City of St. Augustine

Historic Architectural Review Board

A G E N D A *amended

Thursday, October 17, 2019 1:00 p.m.

SHEET
A-21

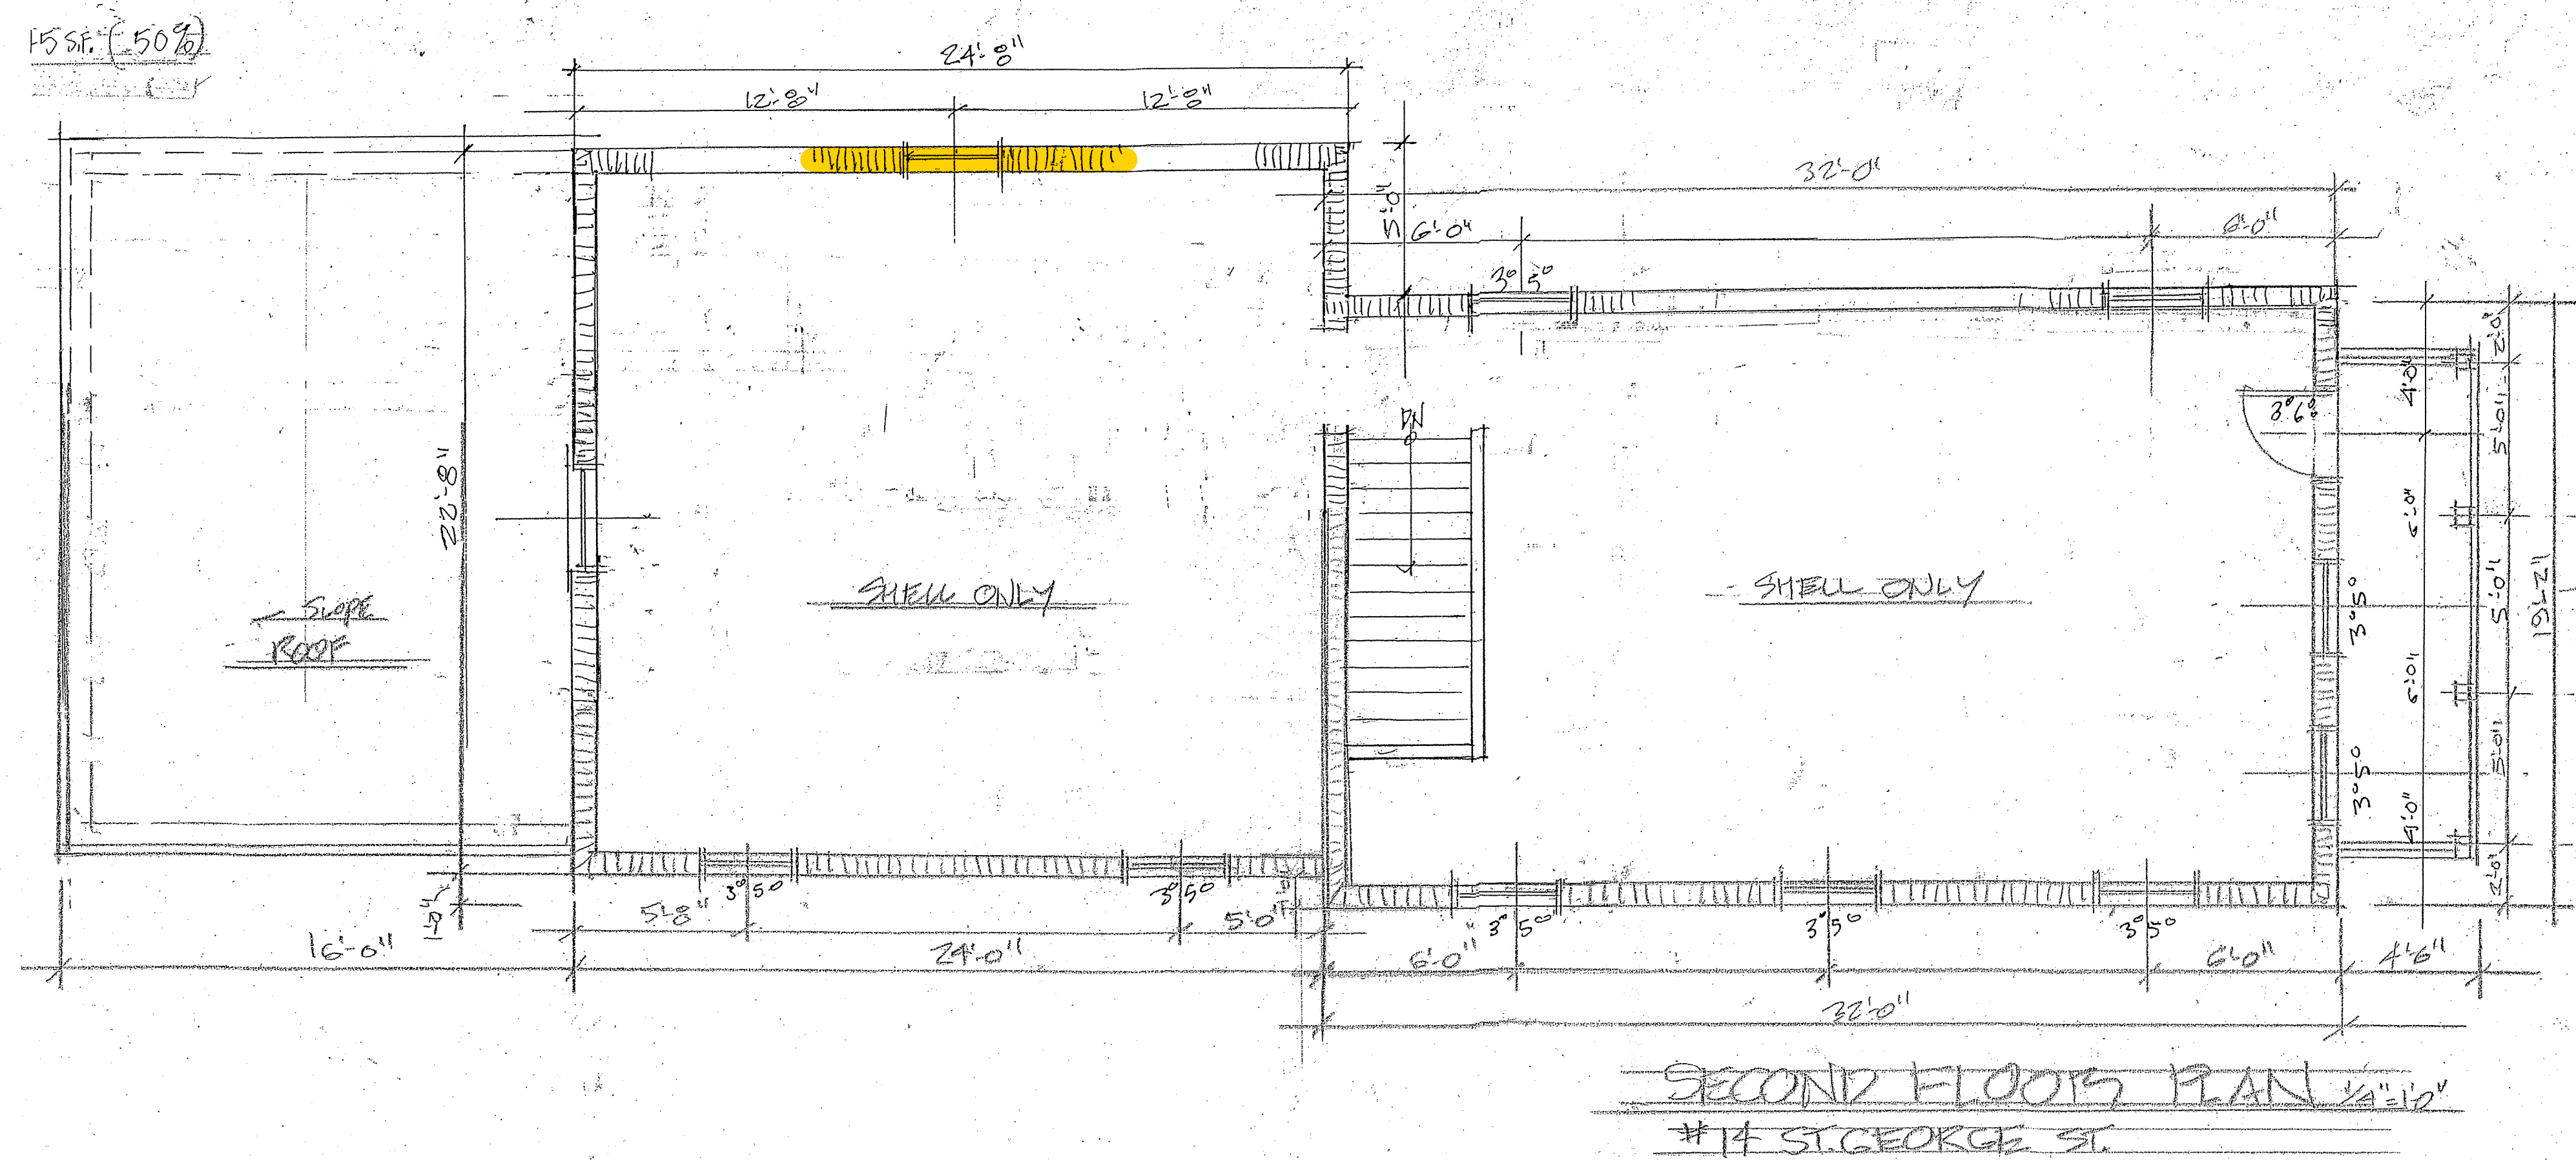
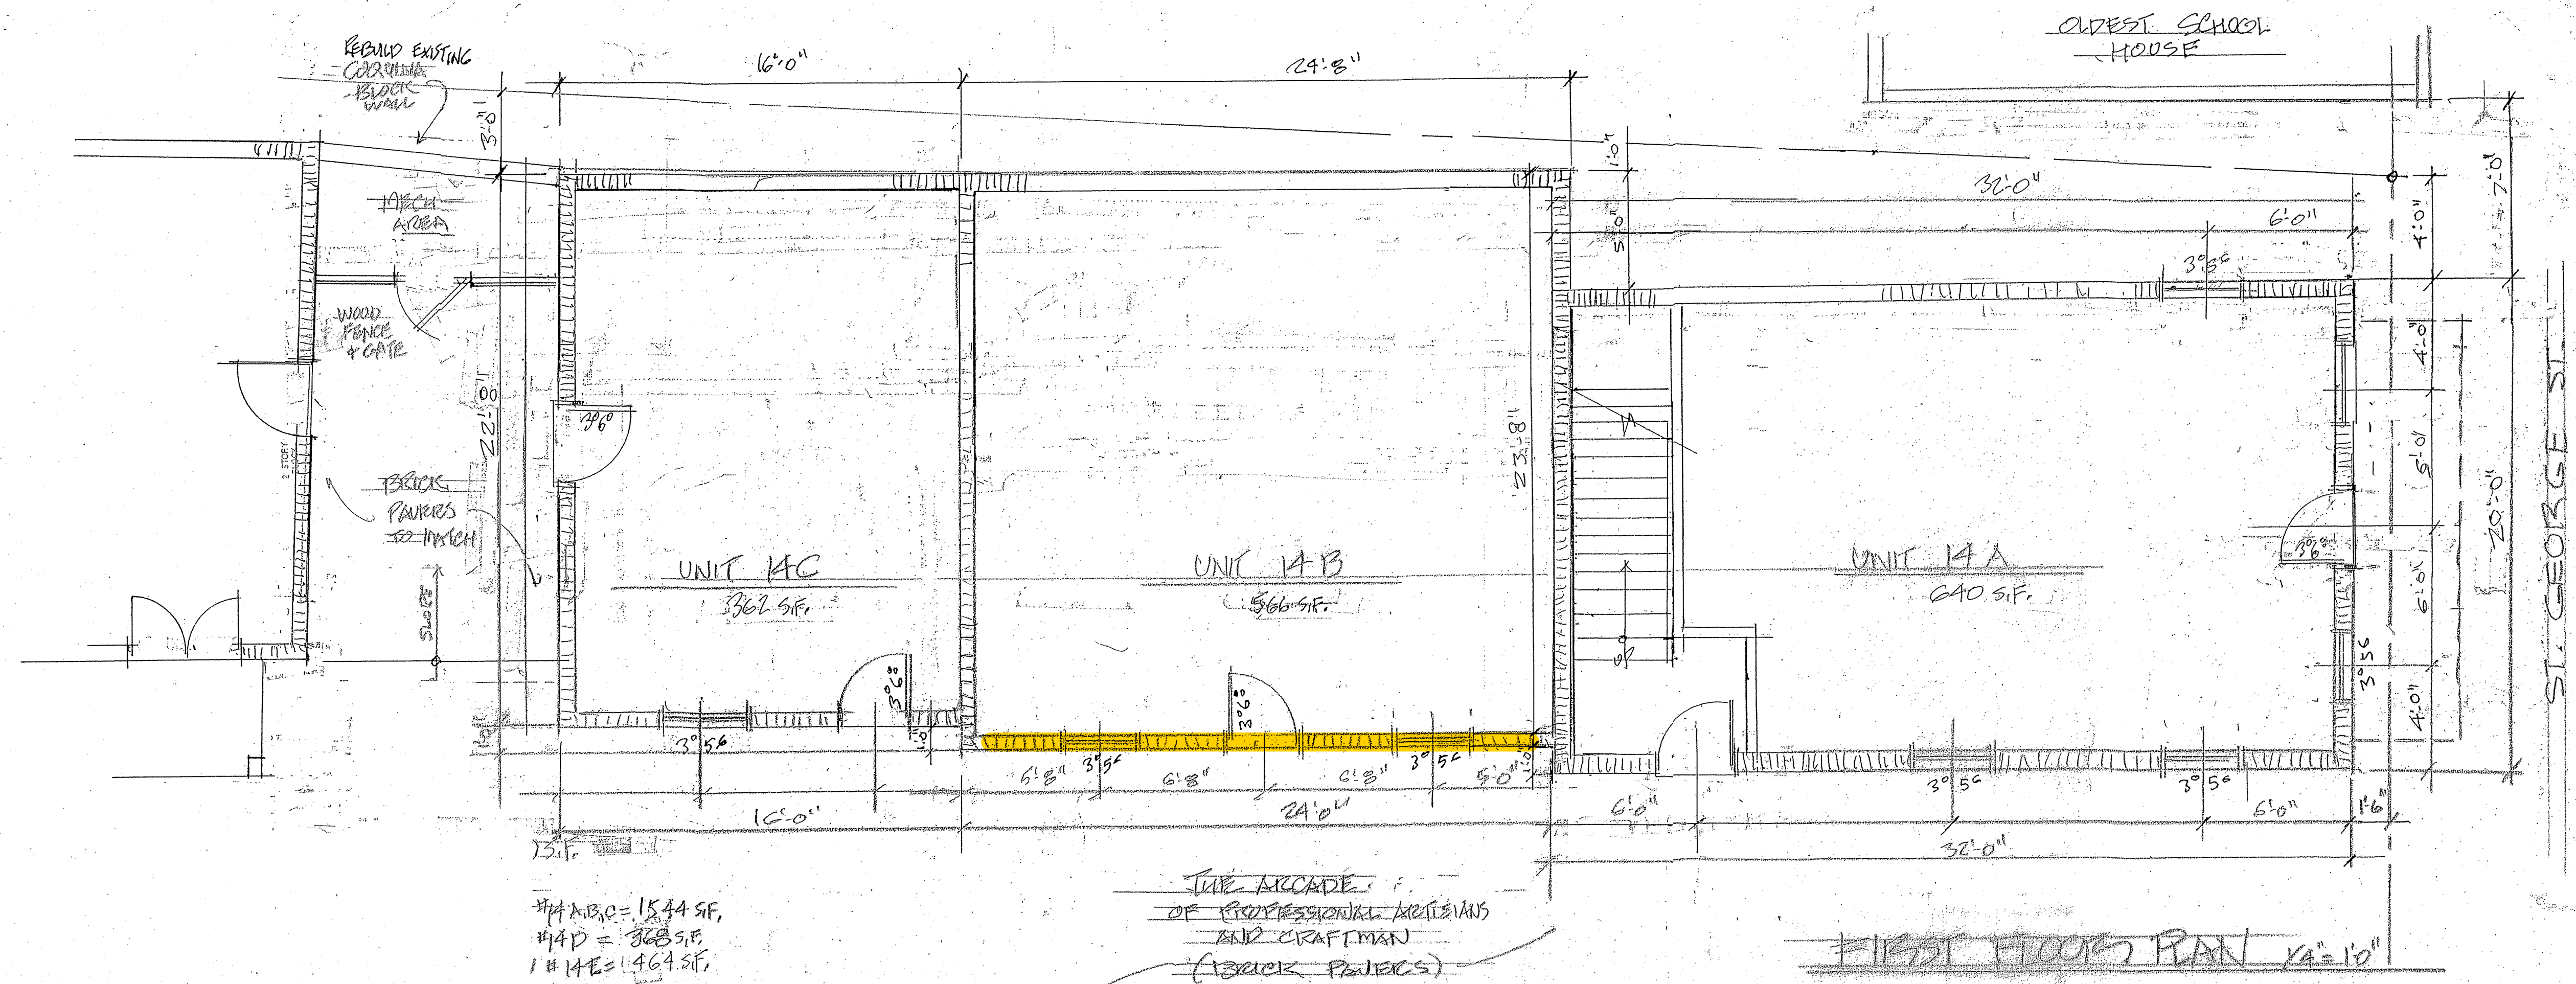
1. Revise double French doors on the balconies to a single wood door that may be paneled and partially glazed.
